**DATE:** SEPTEMBER 3, 2014

**TITLE:** PELI 1150 CASE DESIGN REFINEMENTS

**PRODUCTS AFFECTED:** PELI 1150 CASE

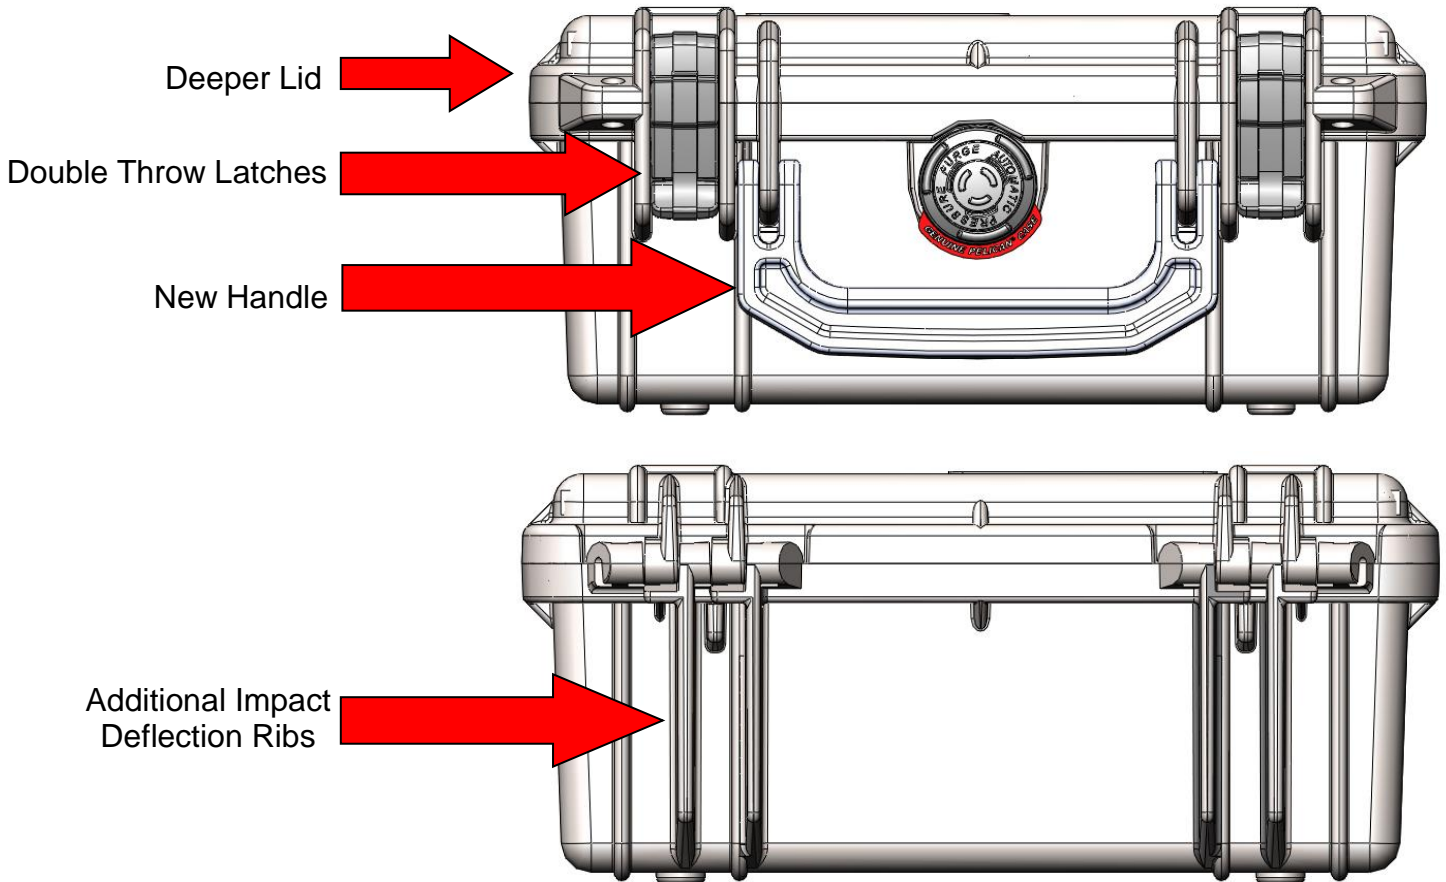
**DETAILS:** The Peli 1150 Case has undergone the following design refinements:

Prior Internal Dimensions			New Internal Dimensions		
Length	Width	Height	Length	Width	Height
8.18"	5.68"	3.62"	8.49"	5.99"	3.75"
Prior External Dimensions			New External Dimensions		
Length	Width	Height	Length	Width	Height
9.12"	7.56"	4.37"	9.44"	7.8"	4.29"
